Safety Audit Report

Stage 1 – Preliminary Design

Proposed School Access, Junction Modifications and Pedestrian and Bus Improvements, Aim High School, Safechester

Spoonford District Council

Location Plans

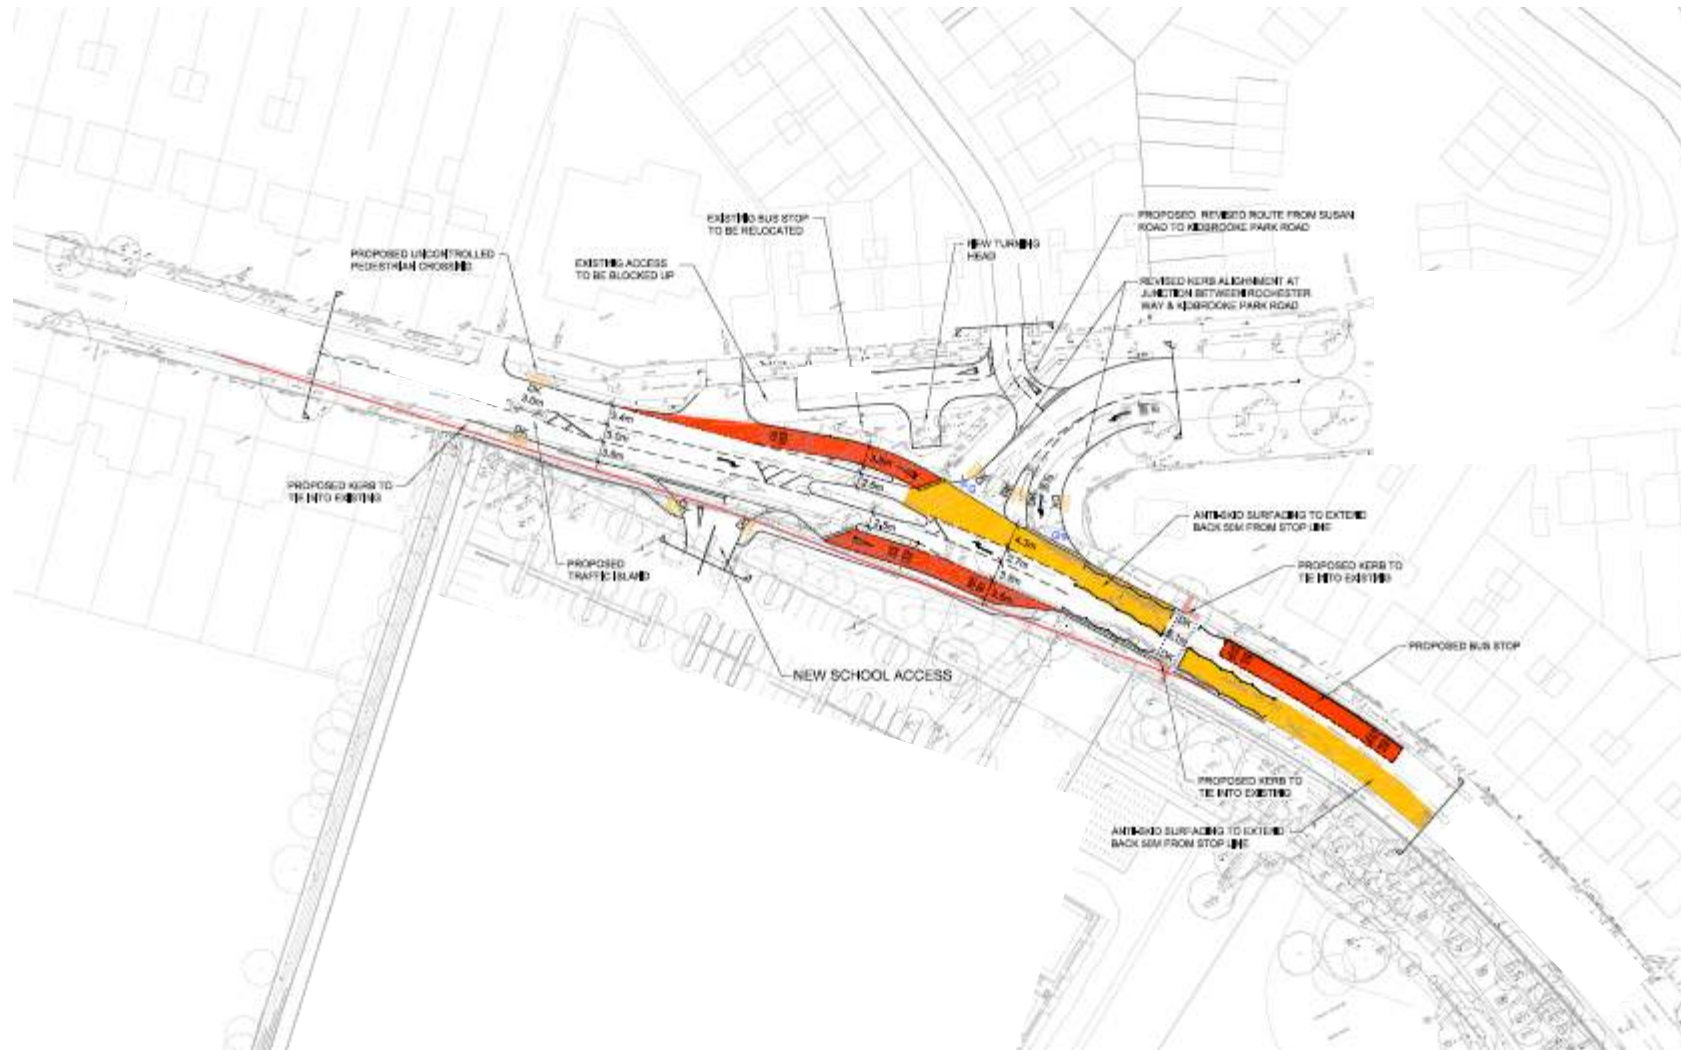
- A1.6 Where possible, all comments and recommendations are referenced to the design drawings and the locations have been indicated on the plan supplied with the audit brief. Where the Audit Team feel that an identified problem is of particular concern, the item is identified ******PROBLEM******.
